PART 70 OPERATING PERMIT OFFICE OF AIR QUALITY

General Motors Corporation 12200 Lafayette Center Road Roanoke, IN 46783

Operation Permit No.: T003-5959-00036

On April 19, 2001, the Office of Air Quality (OAQ) had a notice published in the Fort Wayne Journal Gazette News Sentinel, Fort Wayne, Indiana, stating that General Motors Corporation had applied for a Part 70 Operating Permit to operate an automobile and light duty truck assembly plant. The notice also stated that OAQ proposed to issue a permit for this operation and provided information on how the public could review the proposed permit and other documentation. Finally, the notice informed interested parties that there was a period of thirty (30) days to provide comments on whether or not this permit should be issued as proposed.

B.15 Deviations from Permit Requirements and Conditions [326 IAC 2-7-5(3)(C)(ii)]

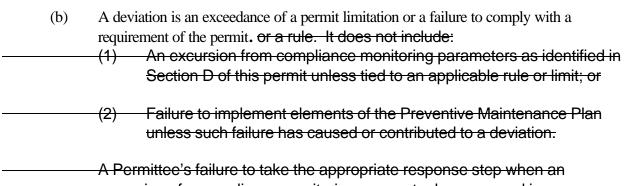
that "failure to take the appropriate response step when an excursion of a compliance monitoring parameter has occurred is a deviation." As discussed in more detail below, there are situations where the expected steps set forth in a compliance response plan may not be the most expedient or appropriate to respond to a given excursion. The facility should not be penalized for taking reasonable steps even if they deviate from the compliance response plan.

It is not a deviation for the Permittee take a response action outside of the approved CRP, however, the CRP will need to be amended and submitted to compliance. Additionally, EPA has specifically stated that if there is a requirement to do something in a permit, it is a deviation when the source does not do it [see 40 CFR 70.6(a)(6)(i)]. IDEM may use enforcement discretion in these cases, but we can not create an exemption through the TV permit. Condition B.15 has been modified as follows:

A Permittee's failure to take the appropriate response step when an excursion of a compliance monitoring parameter has occurred is a deviation.

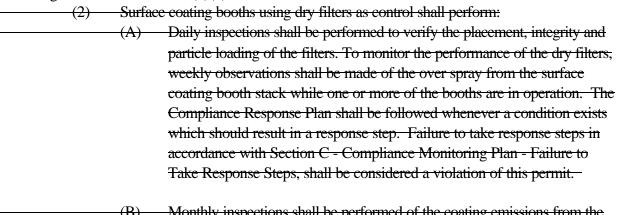
D.4.8(b)(2) - General Motors requests that this term along with Subparts (A) and (B) be deleted since there are no dry filters used on the exhaust system for the topcoat booths.

IDEM agrees. Condition D.4.8(b)(2) has been deleted as follows:

(B) Monthly inspections shall be performed of the coating emissions from the stack and the presence of over spray on the rooftops and the nearby ground. The Compliance Response Plan for this unit shall contain troubleshooting contingency and response steps for when a noticeable change in over spray emission, or evidence of over spray emission is
